Planning Authority Reference Number: 2360027
Your Case Number: PL02.319457

Re: Further Information Response – Proposed 20-Year Quarry Development at Ardkill More and Drumcrow Townlands, Carrickaboy, Co. Cavan

Item 1: Trial Hole Assessment & Geologist Report

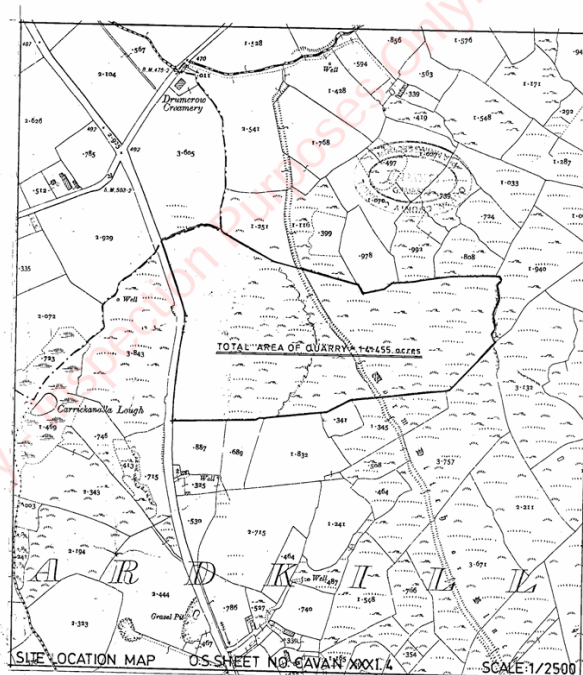
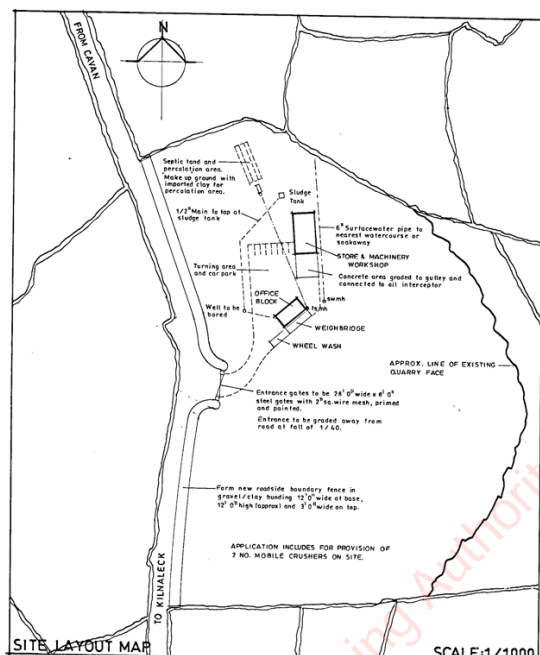
Case Number	Cavan coco 97166
Applicant	John Nulty Ltd
Decision Date	31/07/1997
Description	Erect offices, material testing laboratory, canteen, toilets, store and machinery work-shop, the provision of weigh-bridge, wheel wash facility and 2 no. Mobile crushers
Decision	Cavan coco Granted with Conditions
Key Conditions/Reasons	(1) pre-commencement archaeological survey of Black Pig's Dyke remains, report to National Monuments Service and Council; (6) £5,000 road contribution; (7)–(8) blasting notification and hours restriction (no blasting 1900–0800 or Sundays); (11) dust limit of 200mg/m ² /day at boundary; (21) rehabilitation scheme on cessation, tied to Condition 2 of Reg. No. 7325; (22) £10,000 rehabilitation bond. No quarry lifespan/expiry condition imposed. Note: internal Planning Officer memo (16/07/1997) states monument protection "does not arise" as the Dyke section on-site was already removed — in tension with Condition 1 as imposed.

See attached drawings from planning file from Cavan County Council. For the ease and clarity these drawings have been updated by Michael Fitzpatrick architects and a copy of the relevant permitted area is shown on the attached drawing No. 17169-NLQ-MFA-00-ZZ-DRA-A-501.

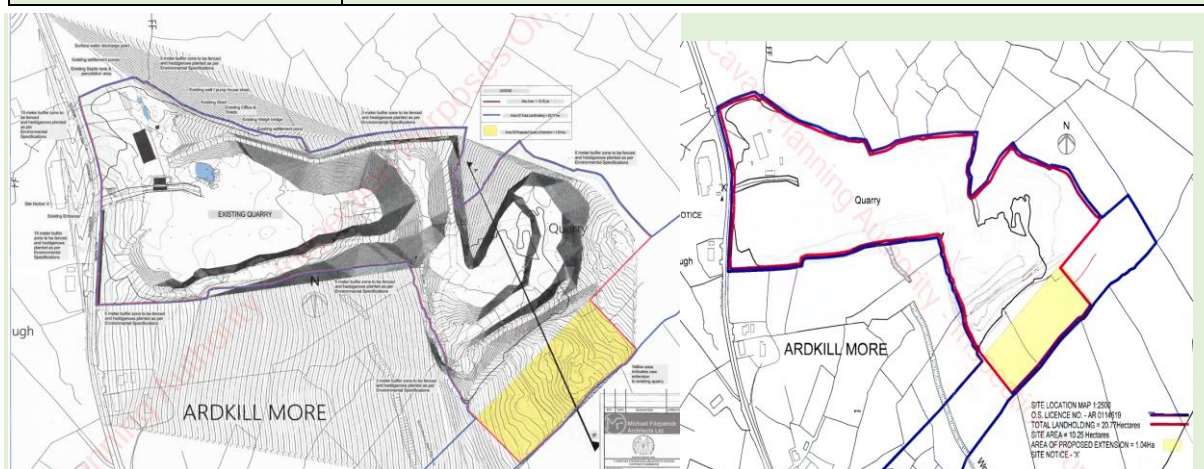
Case Number	Cavan coco: 051801 ACP: PL 02.219928
Applicant	John Nulty Limited
Decision Date	Cavan coco: 13/09/2006 ACP: 27/04/2007
Description	include additional 3.37 hectares of land within the existing quarry envelope - planning reg. no. 7325 ¹ & 97/166, new entrance onto county road and all ancillary site works
Decision	Cavan coco: Granted with Conditions post F.I. ACP: Granted (Conditional)
Key Conditions/Reasons	(2) 12-year quarrying period + 1 year reinstatement, unless retention permission granted before expiry; (3) restoration/working details to 246mAOD (reduced from proposed extent); (12) hours 0700–1800 Mon–Fri, 0700–1400 Sat, no Sun/Bank Holidays; (16)–(18) blasting hours 1100–1700 Mon–Fri, vibration/air pressure/noise limits; (19) dust limit 350mg/m ² /day; (24) archaeological monitoring; (25) restoration bond; (26) s.48 contribution.

50,000 tonnes per annum. The proposed development includes all ancillary site development, areas of stockpiling, landscaping and boundary treatment works above and below ground, including the progressive restoration of the site. An Environmental Impact Assessment Report (EIAR) will be submitted to the planning authority with the application. Significant further information and revised plans have been submitted
Decision	Cavan coco: Granted with Conditions ACP: Refused
Key Conditions/Reasons	(1) inadequate water management/discharge arrangements, risk of environmental pollution, prejudicial to public health; (2) archaeological prematurity — no comprehensive archaeological survey/assessment carried out given proximity to monument.

↳ References 051801, 1162 and QY7 registration — extends the same quarry envelope by 1.04ha.

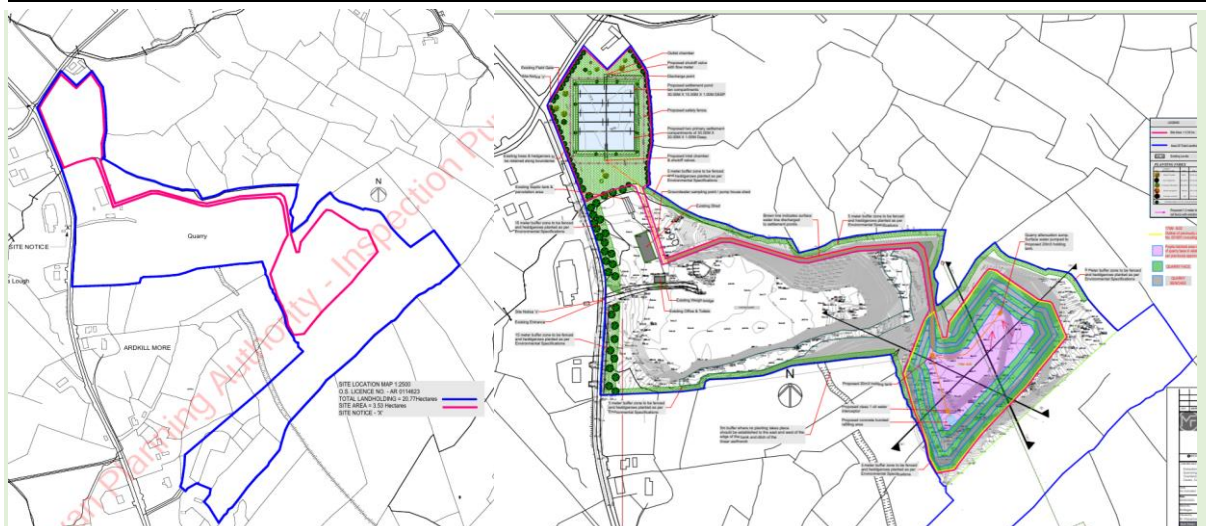
Case Number	Cavan coco 2360027 ACP: ABP-319457-24
Applicant	John Nulty Ltd.
Decision Date	Cavan coco: 12/03/2024 ACP: n/a
Description	for a 20-year permission for quarrying and extraction of rock that will include drilling, blasting, crushing and screening along with alterations to boundaries & all associated site works. Works will also include for the provision of new settlement ponds and installation of associated site drainage infrastructure and surface water pump to proposed new settlement ponds along with provision of discharge outlet via a Klargester Interceptor. Ancillary site works to include for landscape works, planting restoration of the quarry perimeter and reprofiling of overburden as required to facilitate development of the quarry and restoration of the associated site area. An Environmental Impact Assessment Report (EIAR) and a Natura Impact Statement (NIS) have been prepared and accompanies this application, significant further information has been received

Decision	Cavan coco: Granted with Conditions ACP: Appealed

↳ The current application subject to FI request ABP-319457-24 — seeks to supersede the 10-year lifespan set by 20222 with a new 20-year permission.
